| Doc No. PR32_BCB_Bringelly EMS_WMP_R4 | |
| Reason for Revision: Conditions of Approval for SSD_5684 S16-18 Resubmission | |

Bringelly Brickworks Groundwater Management Plan

Table 2. NRAR Groundwater Management Plan Comments

| Plan of: | Bringelly Clay Mine Groundwater Management Plan - Cross Section | Location: | Bringelly Clay Mine Off Greendale Road, Bringelly, NSW | Source: | Photomapping 2015 & Landair 2017 | Our Ref: | 8006_BR_GMP_C002_V0_F2.cdr |

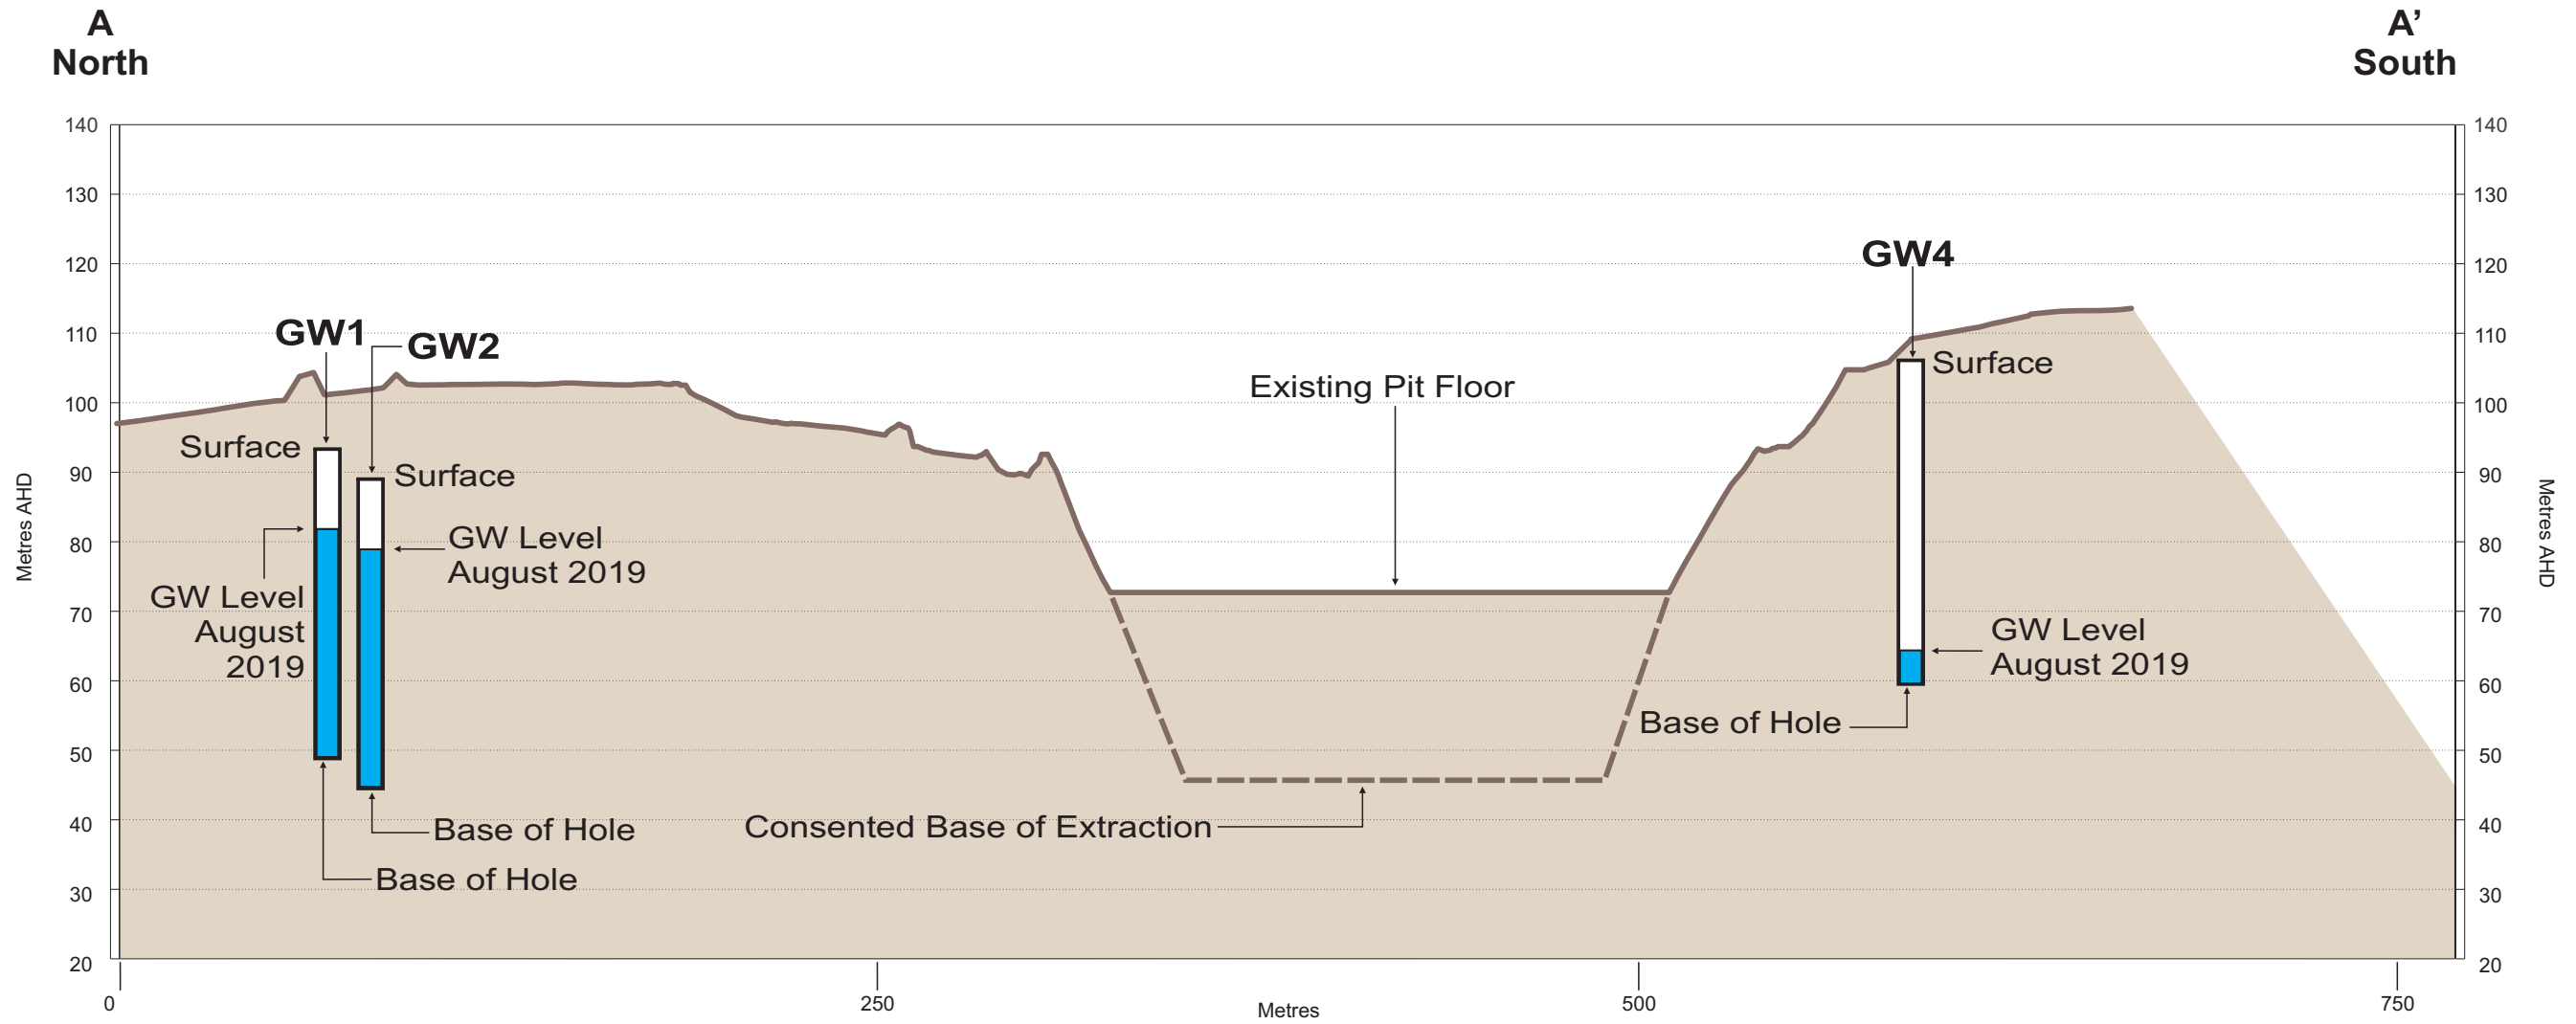
| Comment | Where Addressed in this Report |
|---|--|
| The Groundwater Management Plan must include water level elevations of all water bodies on the site, together with groundwater elevations measured on the same day, and provide a discussion of the relative levels in respect of hydraulic gradients and flow directions in the body of the document. Section diagrams illustrating the relative elevations of the existing (and any proposed) quarry pits and groundwater levels need to be included to support the calculations of groundwater take volumes. | Section 5, Section 7, Figure 4, Figure 5 |

From the cross-sectional plots of the bores and the Main Pit it (see Figure 4) appears that groundwater is lowest in the south and below the Main Pit level, and rises to the north (see Figure 5). In an eastward direction the levels appear to gradually decrease. This is consistent with the hydraulic gradient discussed in the EIS of flows from the north toward the south east, towards the South Creek locality to the east of the site. It is evident that the Main Pit has not progressed to the groundwater level and no groundwater seepage has been noted to date, therefore groundwater inflow measurements cannot be undertaken at this stage.

| Plan of: | Bringelly Clay Mine Groundwater Management Plan - Mine Stages & Conceptual Bore Locations | Location: | Bringelly Clay Mine Off Greendale Road, Bringelly, NSW | Source: | Photomapping 2015 & nearmap - Image Date 12/01/2019 | Our Ref: | 8006_BR_GMP_C006_V0_F6.cdr |

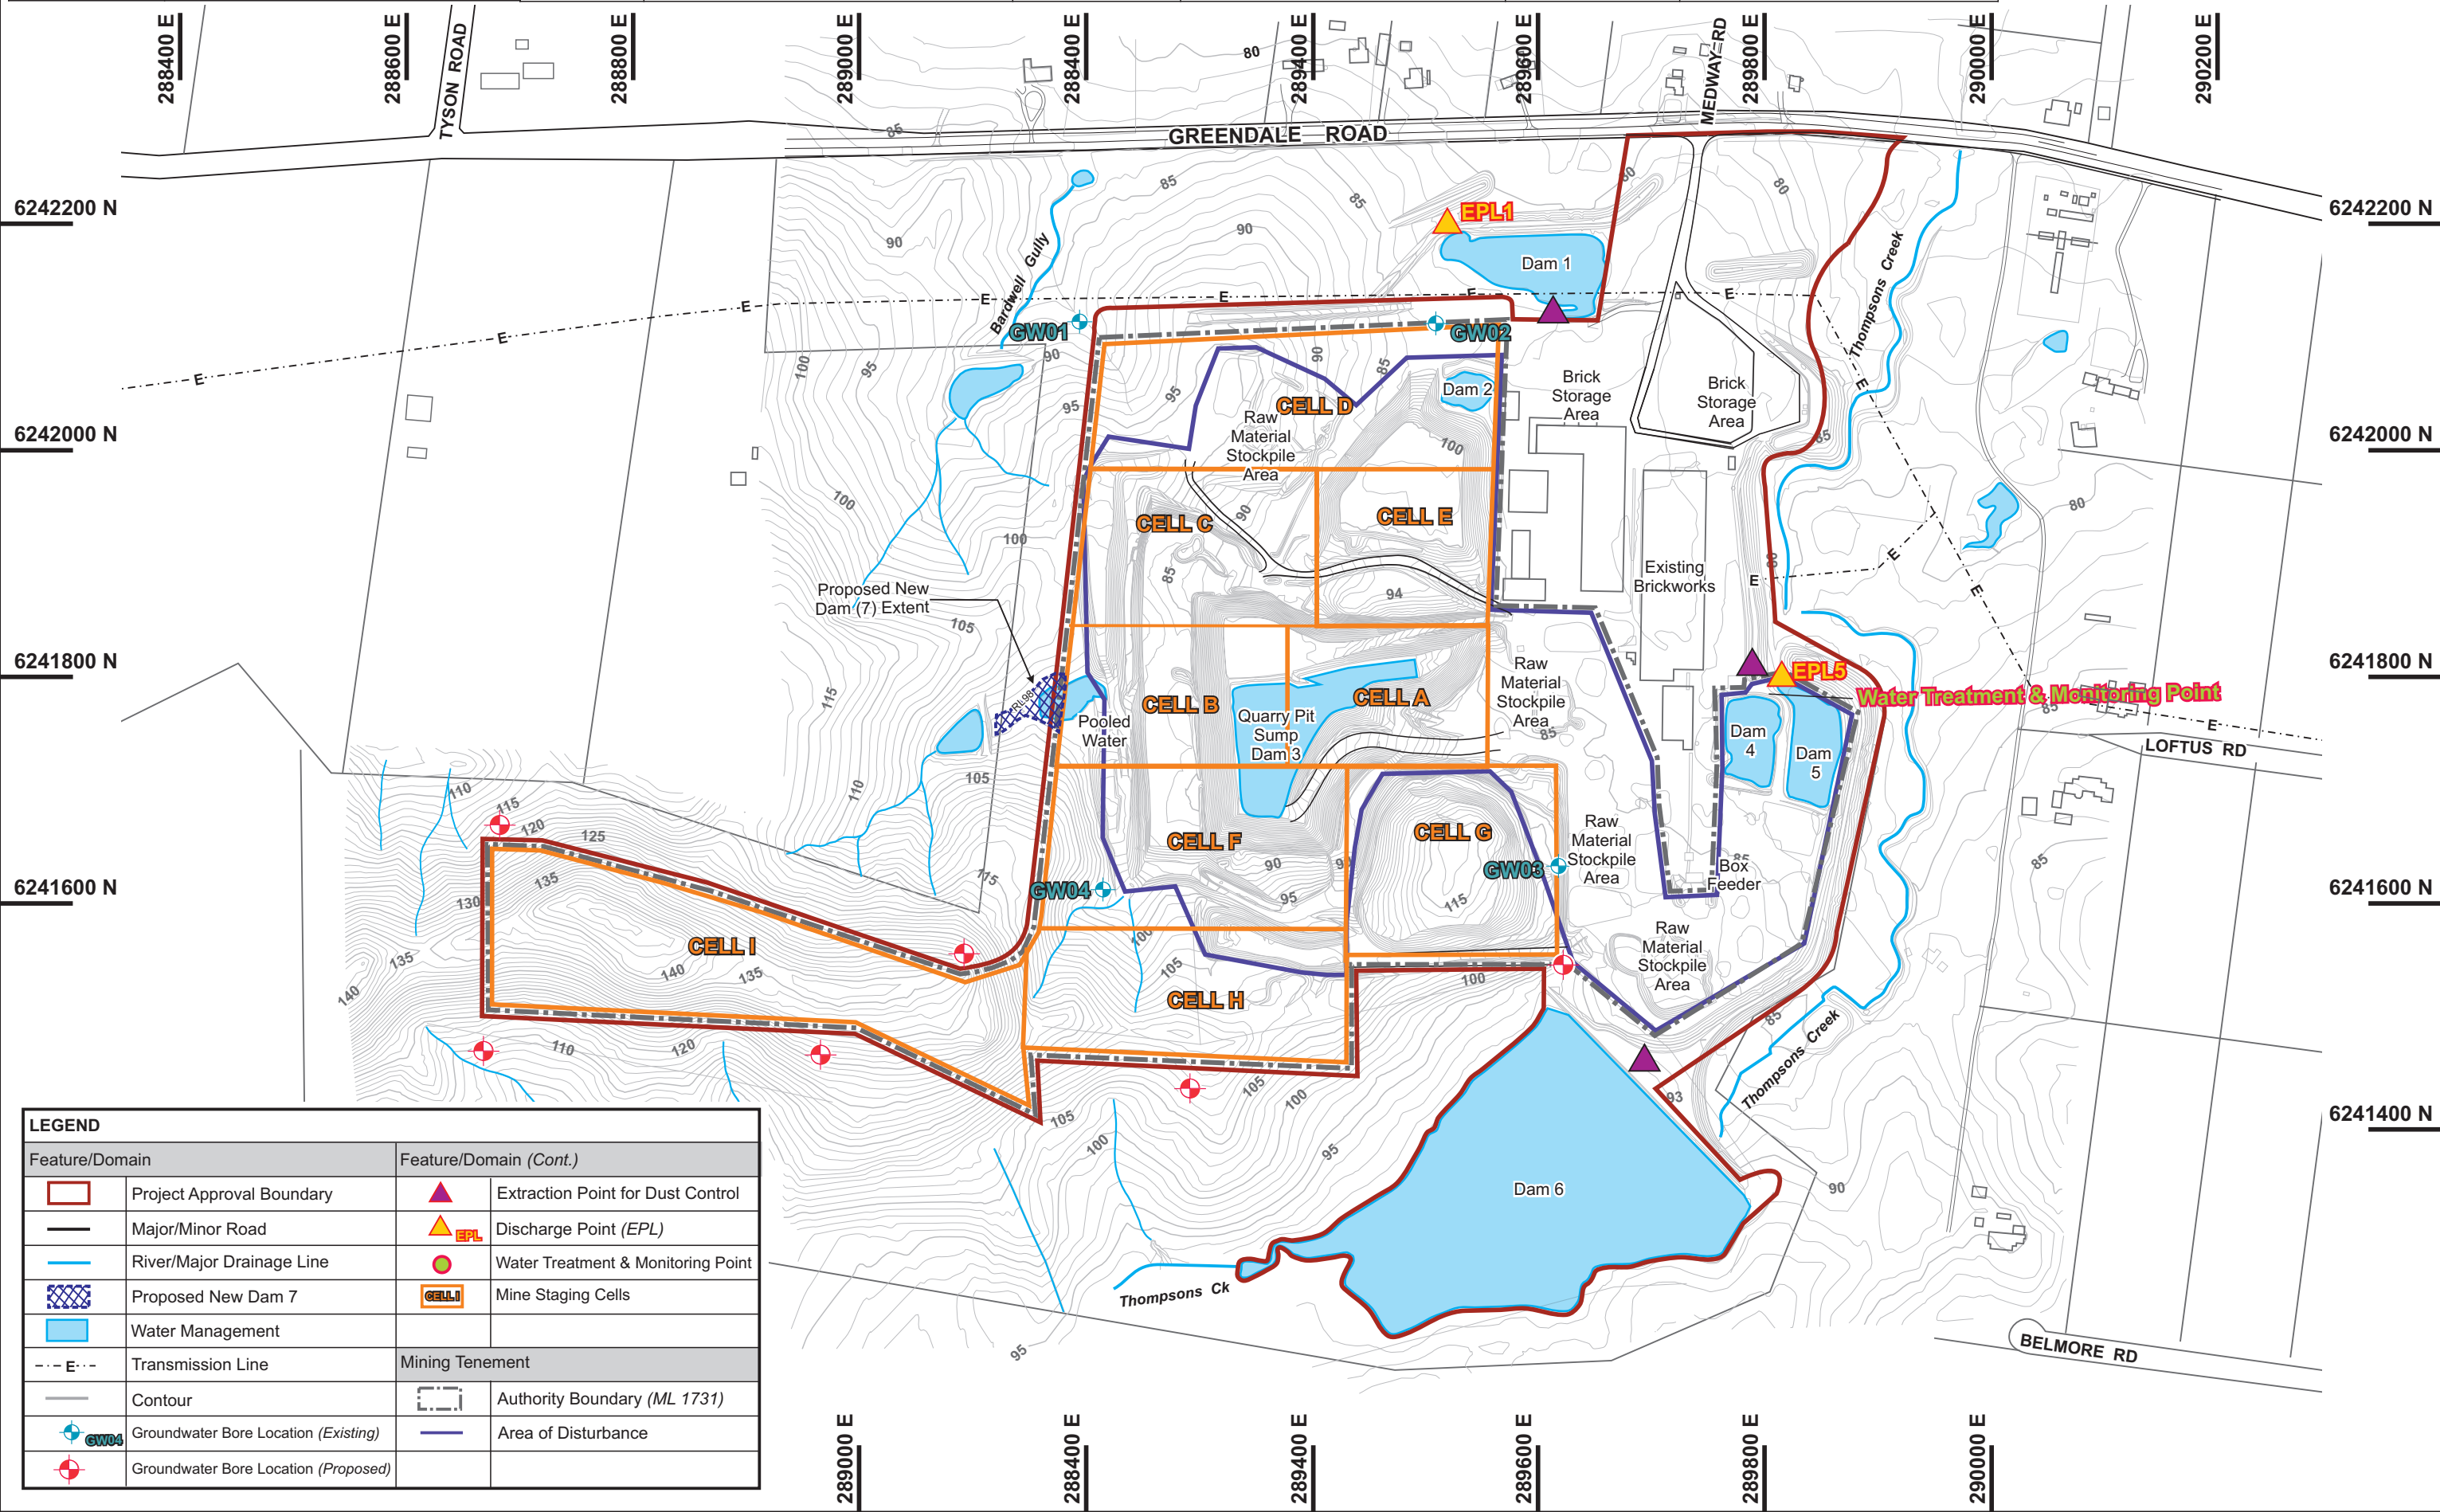
| Comment | Where Addressed in this Report |
|---|--|
| The Groundwater Management Plan must include an updated project planning diagram, illustrating potential quarrying activities (i.e. development stages and intended extraction activity) and nominating replacement monitoring bore locations where there is a possibility of existing installations being damaged, destroyed or removed by ongoing site operations. | Figure 6 |

As shown in *Figure 6*, the existing bores are located around the perimeter of the current void. GW1 and GW2 are outside the mining extension area in the north (Cell D) and are unlikely to require relocation. GW3 may require relocation prior to mining commencing within Cell G and GW4 will require relocation prior to mining in Cell F. Conceptual locations of future bores are also shown on *Figure 6*.
